**Historic Architectural Review Commission
Staff Report for Item 3**

Application Number: H16-03-0033

Address: #724 Caroline Street

Description of Work:

Color-coded 1948 Sanborn map.

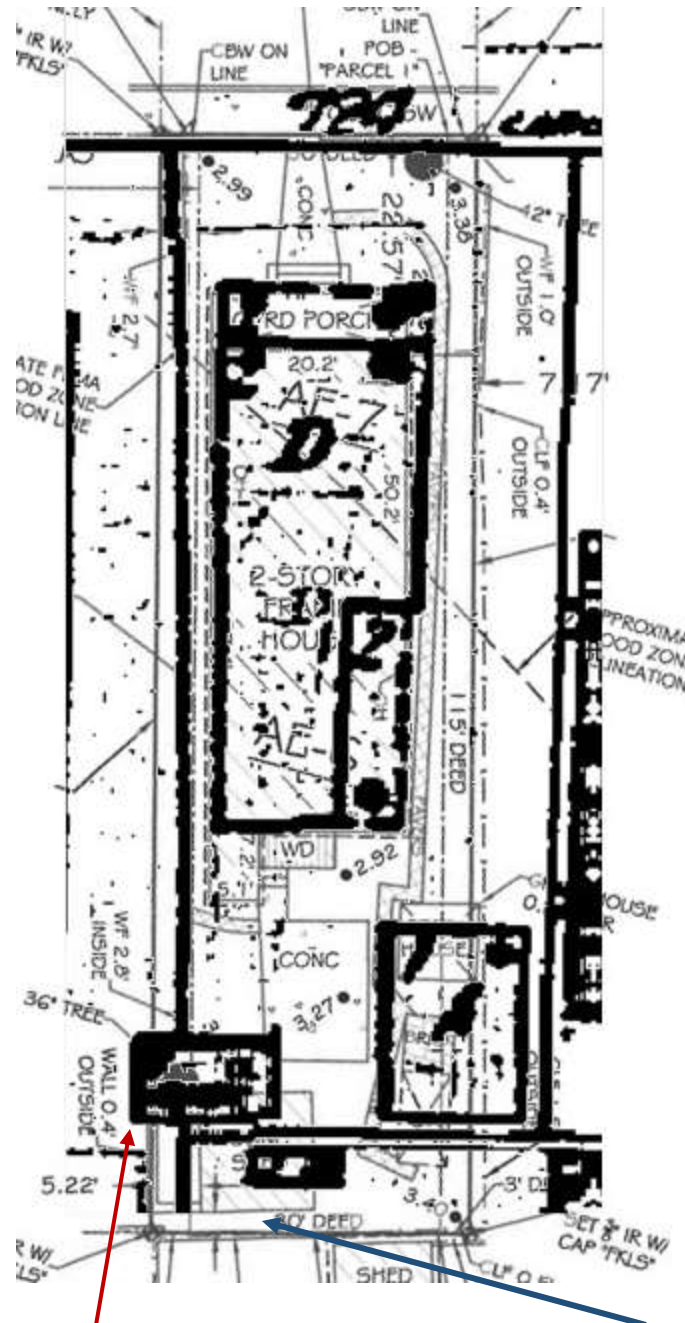
It is important to mention that staff has studied available information regarding the above ground cistern - “concrete shed” on the survey, that is proposed to be demolished. The Sanborn maps from 1899 through 1948, depict a cistern on the rear yard of the property. The 1948 color-coded Sanborn map depicts the cistern in blue color, which means that the structure is in concrete or masonry. The 1962 Sanborn map does not portray any accessory structure on the site. The separation between the cistern and the historic rear footprint of the house in the Sanborn maps versus the location of the “concrete shed” in the survey are very similar. In addition, the construction materials are definitely more than 50 years old. It is evident that the height of the structure was altered through time and that the old mango tree roots have done some damage to the structure. For those reasons, staff will consider and review the request for this structure to be demolished as a historic resource.

The structure in question is not irrevocable compromised by extreme deterioration. There are some cracks due to the mango tree root system. The cistern has a wooden gable roof with metal v-crimp.
